RFP Questions and Clarifications Memorandum

To: Vendors Responding to RFP Number 4603 for the Mississippi Development Authority (MDA)

Subject: Responses to Questions Submitted and Clarifications to Specifications

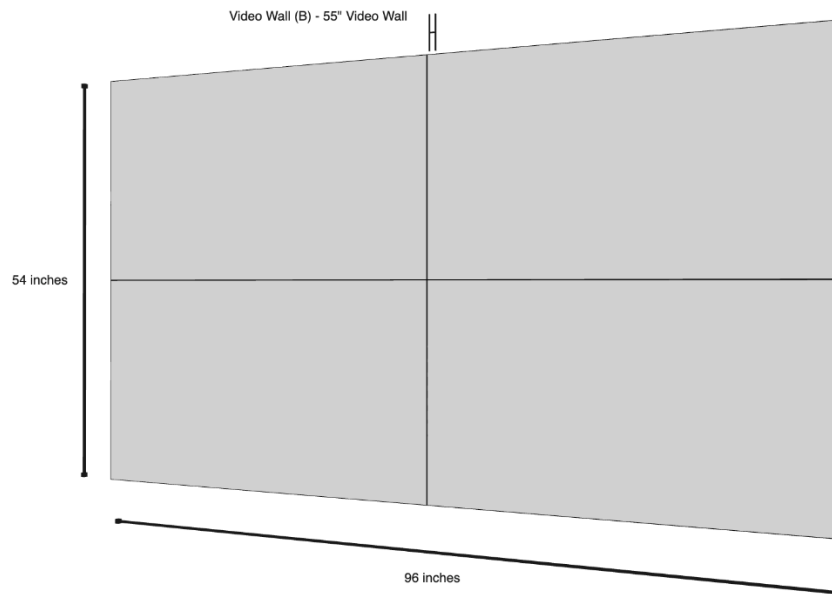
Question 14: 1) For Video Wall (A), the RFP specifies dimensions of 80.44” wide x 45.43” high x 2.712” deep. However, based on our calculations, the dimensions would be approximately 81” wide x 54” high when using a 55” video wall panel.

2) Similarly, for Video Wall (B), the RFP lists the size as 65.12” wide x 37.79” high with 6 panels. According to our calculations, the dimensions would be around 48” wide x 27” high for one panel, and 96” wide x 27” high for two panels.

Could you please confirm if the dimensions within this range would be acceptable for your project requirements? Please see our mockups below.

Response: The width dimensions of the video walls are flexible by two inches; therefore, the dimensions within range of the mockup would not be acceptable. See Amendments 5 and 6 above. The RFP does not specify a number of panels per video wall.
